Addendum 15 – Regulation No. 16

Revision 7 - Amendment 1

Supplement 3 to the 06 series of amendments – Date of entry into force: 15 July 2013

Uniform provisions concerning the approval of:

Figures 1 to 7,

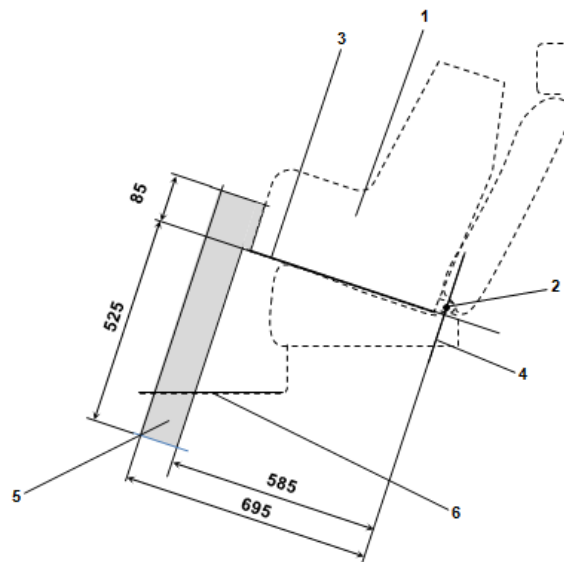
Item 2. of the Key, amend to read:

1. ...
2. Dashed line marks area where a support leg, or similar, of a specific vehicle CRS is allowed to protrude.

"Figure 8
Side view of the i-Size support leg installation assessment volume for assessing compatibility of the i-Size seating positions with support legs of i-Size child restraint systems

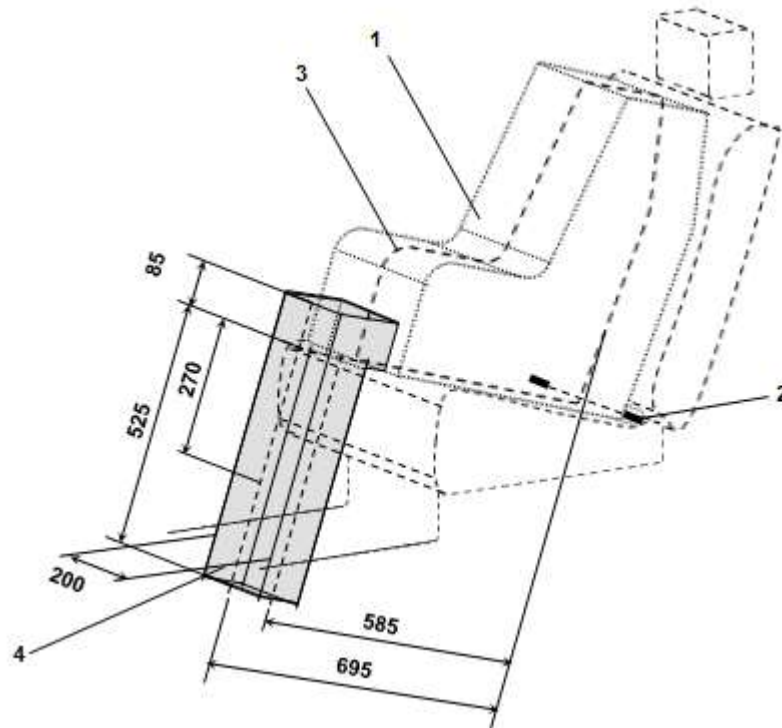
Insert new Figures 8 and 9, to read:

1. Child Restraint Fixture (CRF).
2. ISOFIX low anchorages bar.
3. Plane formed by the bottom surface of the CRF when installed in the designated seating position.
4. Plane passing through the lower anchorage bar and oriented perpendicular to the median longitudinal plane of the CRF and perpendicular to the plane formed by the bottom surface of the CRF when installed in the designated seating position.
5. i-Size support leg installation assessment volume representing the geometrical boundaries for an i-Size ISOFIX child restraint system support leg.
6. Vehicle floor.
